<b>Title - Sujet</b> BIO Ellis Lab Roof	
<b>Solicitation No. - N° de l'invitation</b> EB144-210747/A	<b>Amendment No. - N° modif.</b> 003
<b>Client Reference No. - N° de référence du client</b> EB144-21-0747	<b>Date</b> 2020-09-29
<b>GETS Reference No. - N° de référence de SEAG</b> PW-SPWA-405-6038	
<b>File No. - N° de dossier</b> PWA-0-84038 (405)	<b>CCC No./N° CCC - FMS No./N° VME</b>
<b>Solicitation Closes - L'invitation prend fin</b> <b>at - à 02:00 PM</b> <b>on - le 2020-09-30</b>	<b>Time Zone</b> <b>Fuseau horaire</b> Atlantic Daylight Saving Time ADT
<b>F.O.B. - F.A.B.</b> <b>Plant-Usine:</b> <input type="checkbox"/> <b>Destination:</b> <input checked="" type="checkbox"/> <b>Other-Autre:</b> <input type="checkbox"/>	
<b>Address Enquiries to: - Adresser toutes questions à:</b> Kendell (PWA), Byron	<b>Buyer Id - Id de l'acheteur</b> pwa405
<b>Telephone No. - N° de téléphone</b> (902) 497-5345 ( )	<b>FAX No. - N° de FAX</b> (902) 496-5016

La modification no 003 vise à répondre aux questions des soumissionnaires, comme suit :

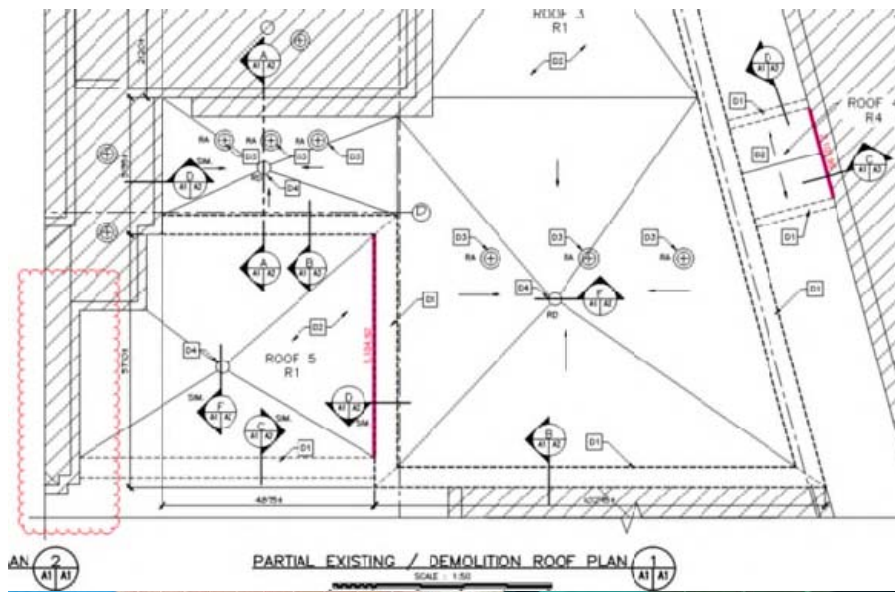
**Question 1:** Upon reviewing the demolition plans and also from my site visit I remarked something. I noticed that on one area of the roof, there is brick located on two opposite walls. However; only one wall is calling for the brick to be removed. Is there no need for the other wall to have the masonry removed? Please see below.

**Réponse 1:** Detail D would apply to this section of wall as well.
